Revision Transmittal Sheet

This sheet transmits Revision 1 of Service Bulletin SB-328-57-239 titled:

Wings – Missed rivets on flap arm 2 R/H and L/H

No.: SB-328-57-239

Fig. 2

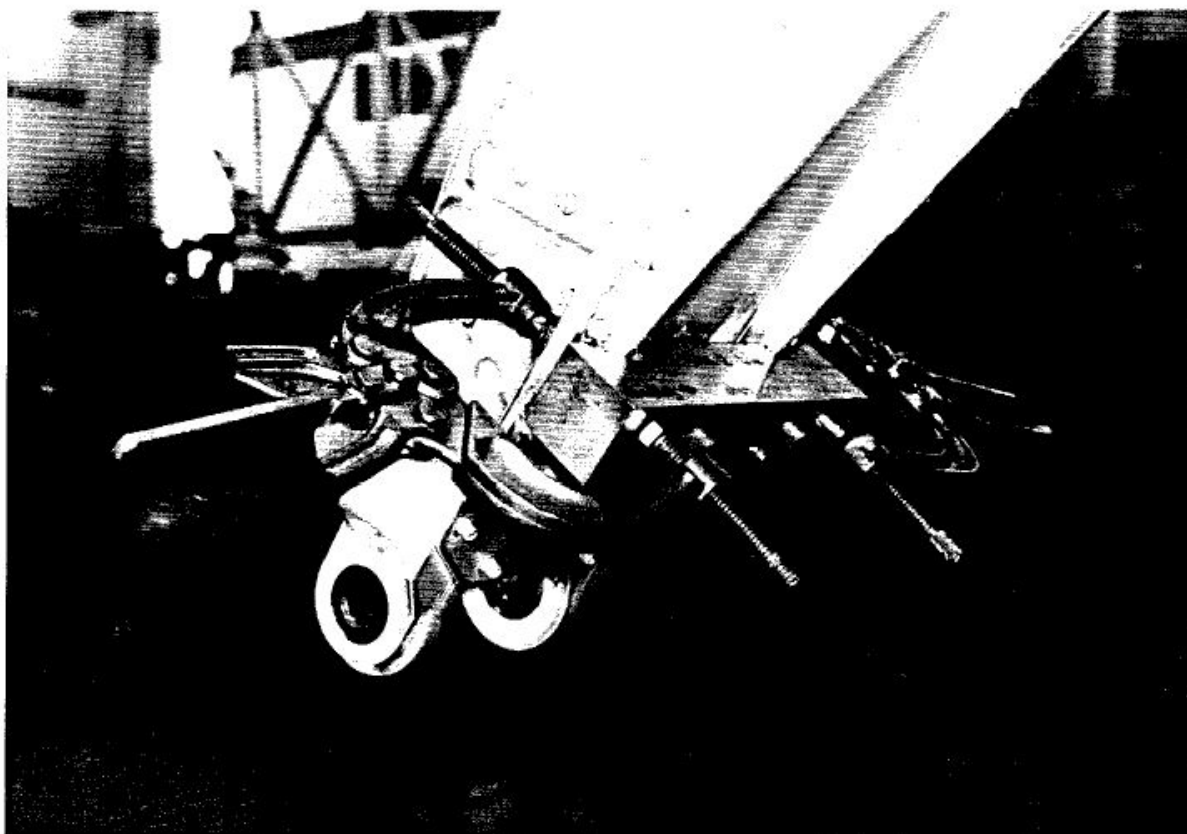
- 1) Position drilling jig P/N 001U575A0600 on bottom side of flap arm 2, refer to fig.1 and fig. 2.
- 2) Drill fastener holes dia 3,1mm (0.125 in.) and then enlarge to 4,1mm (0.1633 in.).
- 3) Remove drilling jig.
- 4) Install the Hi-Lok fasteners (item no. 1 and 2) according to the SRM.
- 5) Renew surface protection according to the SRM.
